# Response to Submissions

Cooma Road Quarry Continued Operations Project

**COOMA ROAD QUARRY  
CONTINUED OPERATIONS PROJECT**  
Response to Submissions

Project Director: **John Merrell**  
Project Manager: **Kirsty Davies**  
Report No. **2992/R08/Final**  
Date: **January 2013**

FIGURE 2.6

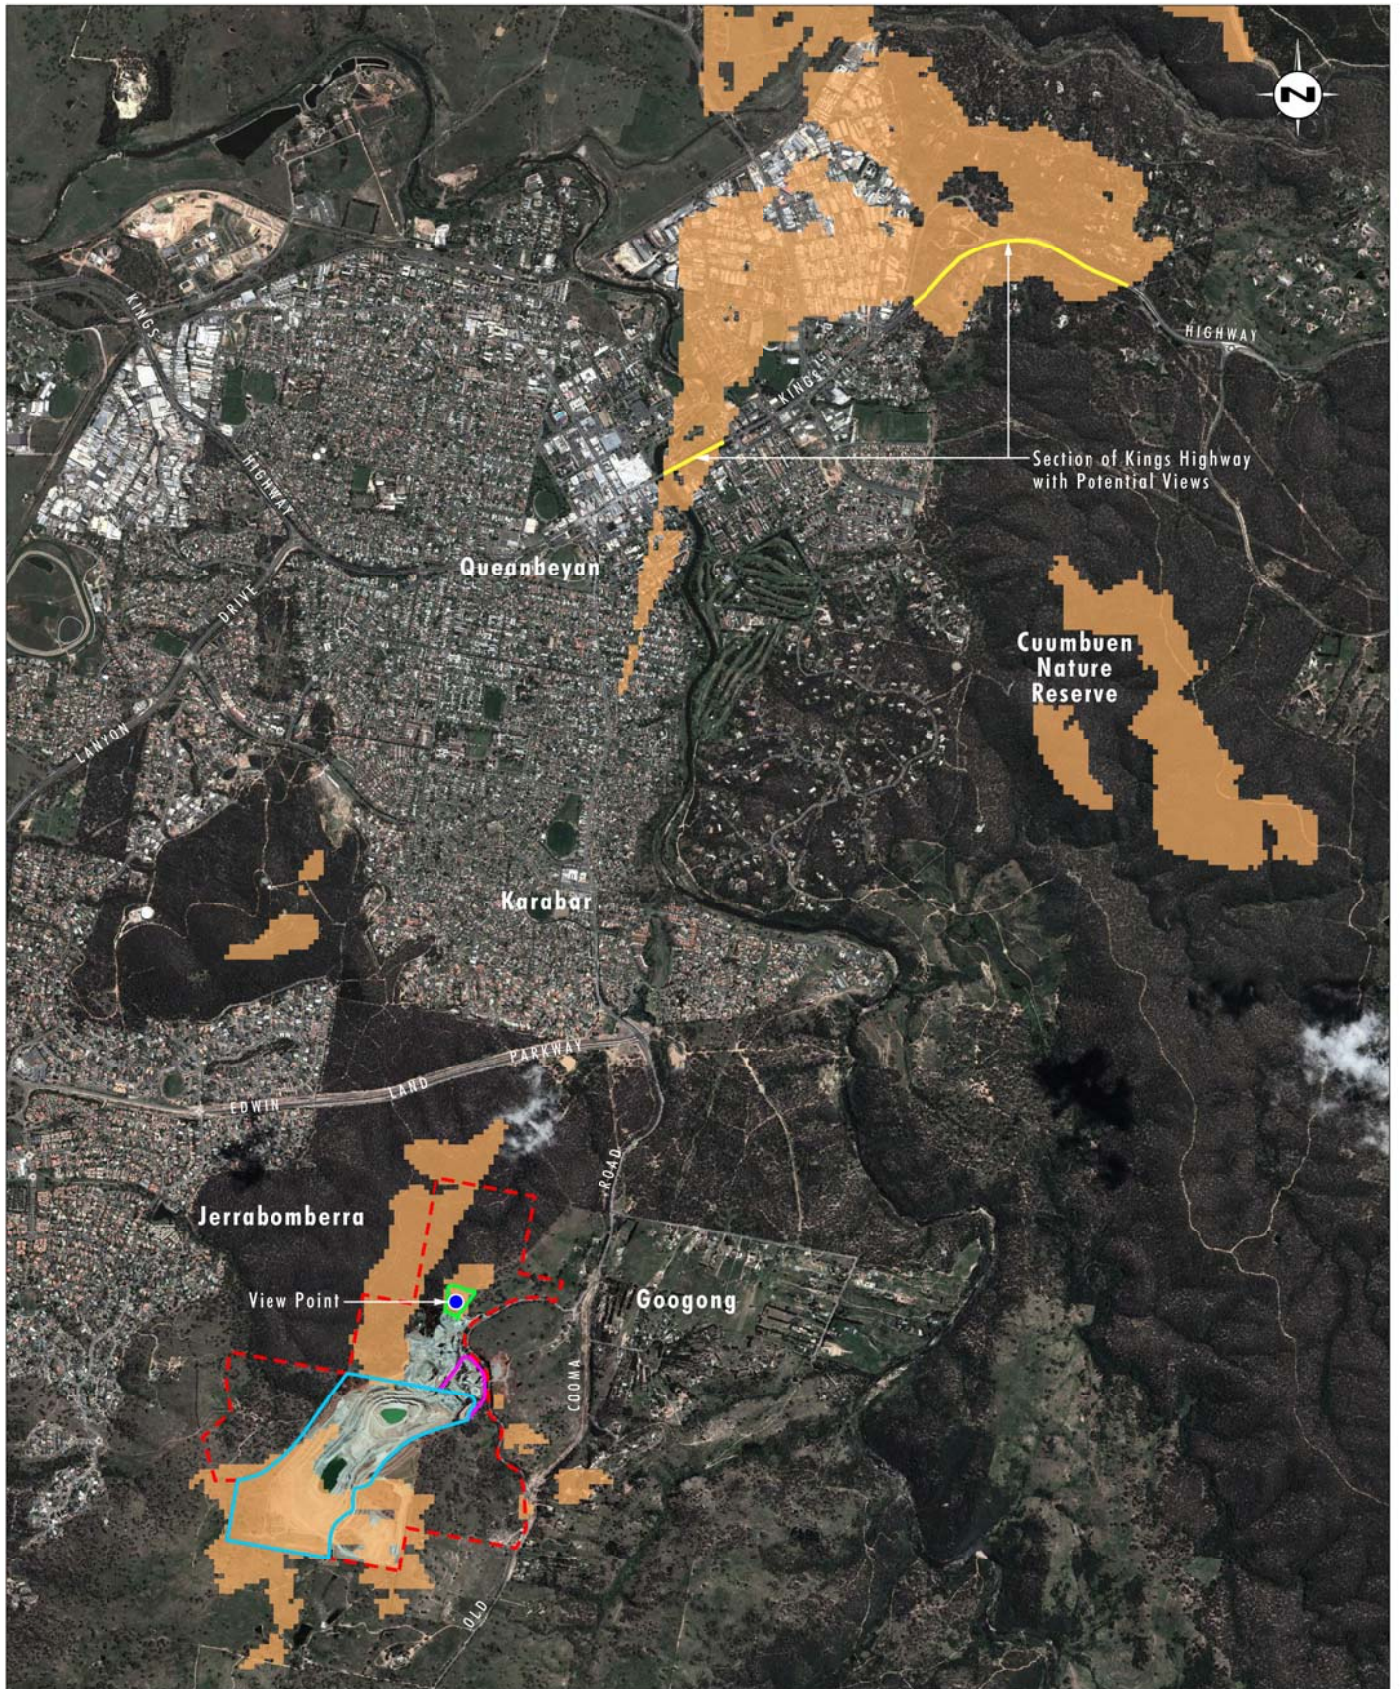
The visual analysis supplied in the EIS provides a very narrow view of the development from the immediate vicinity of the quarry. The analysis should also be conducted from vantage points such as Kings Highway (new alignment) and other vantage points which are further afield than the current analysis provides (Action 1.3 prior to consent).

The visual assessment, as presented in Section 5.12 of the EIS, focuses on the most potentially affected areas and is considered adequate for the Project considering the minimal change in the overall visibility of the Project. The changes proposed as part of the Project require only minimal changes to the existing quarry and the majority of changes will not result in changes in the visibility of the Project for the majority of surrounding community viewing locations. The changes required will have an insignificant impact on the visual amenity of all receivers. The major visual change from the Project is the new infrastructure area. Accordingly, the visual assessment focussed on the new infrastructure area.

As shown in **Figure 2.6**, a section of Kings Highway may have potential views of the proposed new infrastructure area. The analysis presented in **Figure 2.6** is based on topography only and does not make any allowances for vegetation or other shielding. As the new infrastructure area will mostly consist of a number of buildings, it is considered that any views that are not shielded by vegetation will be consistent with the views of the surrounding area (with numerous houses and other buildings).

It is noted that some views of the existing quarry pit are available from locations along the Kings Highway. The current views are primarily of an area of the existing quarry pit which is not proposed to change as a result of the Project. As shown in **Plate 2.1** and **Plate 2.2**, the existing views of the existing quarry pit from Kings Highway are over a long distance and are not highly visually intrusive. Based on the topography only analysis presented in **Figure 2.6**, the proposed quarry pit extension area and new infrastructure area may have some potential

views from a section of Kings Highway. However, topographic and vegetative shielding combined with the long distance views means that Kings Highway and areas further afield will have little to no change in visual amenity. Any distant views that are available of the new infrastructure area and extended quarry pit would be generally consistent with the existing views from these areas. Based on the above, the Project is not considered likely to result in significant changes to visual amenity from the Kings Highway area.
